## S E R V I C E N O T E

**44477A Form C Relay**

**44487A Terminal Block shipped with 44477A Relay Module used with Agilent 3499A/B or 3488A Switch Systems.**

**WARNING****Possible Shock Hazard**

**Figure 1. Picture of the Terminal Block**

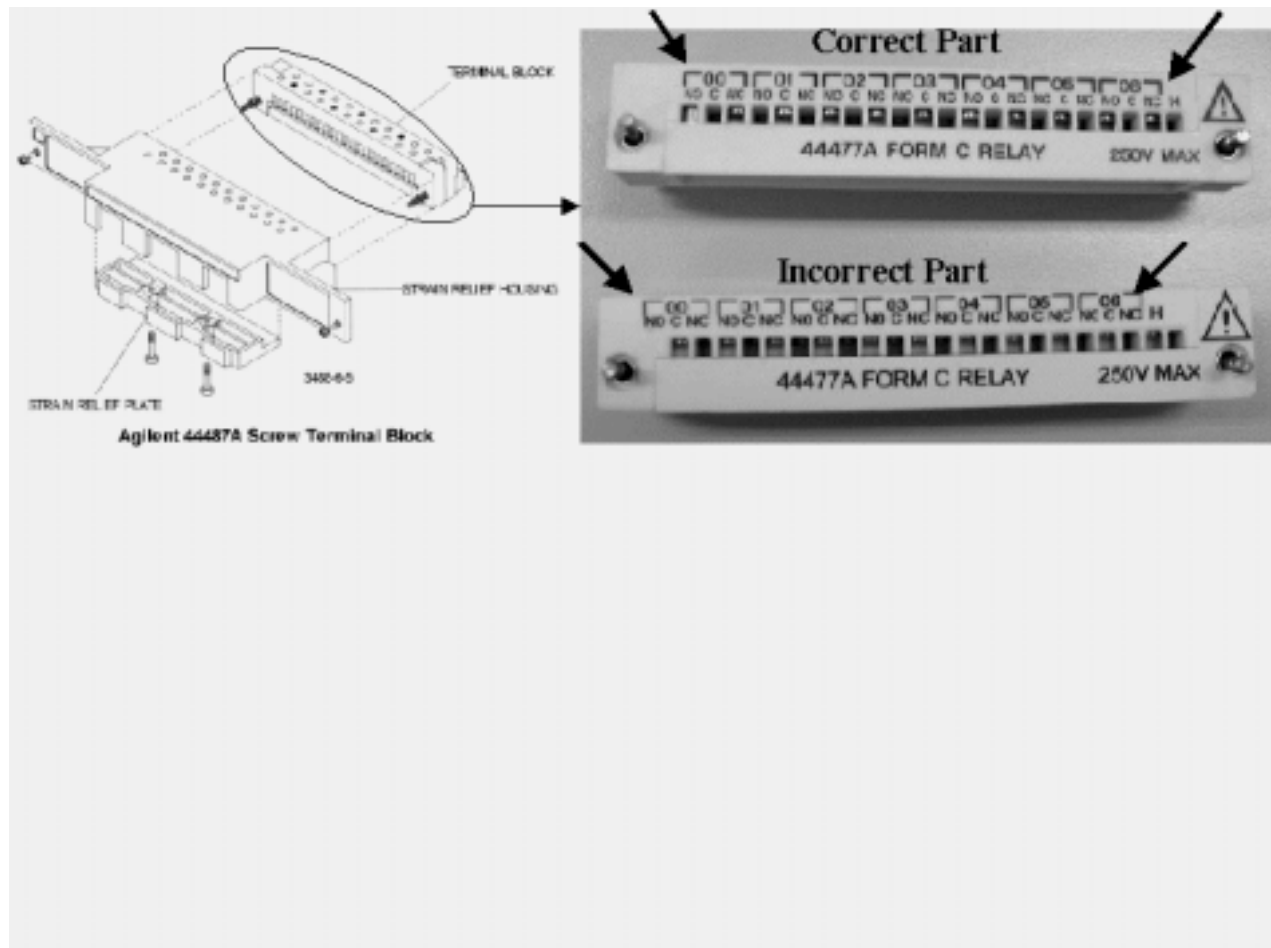
Some Agilent 44487A Terminal Blocks shipped with Agilent 44477A Relay Modules have incorrect silkscreen printing. On the incorrect terminal blocks the silkscreen printing is shifted from the correct position. The silkscreen printing on correct parts should correspond to the connector holes. Please see the below photo.

Agilent will replace the incorrect Terminal Block (44487A) with a correct one.
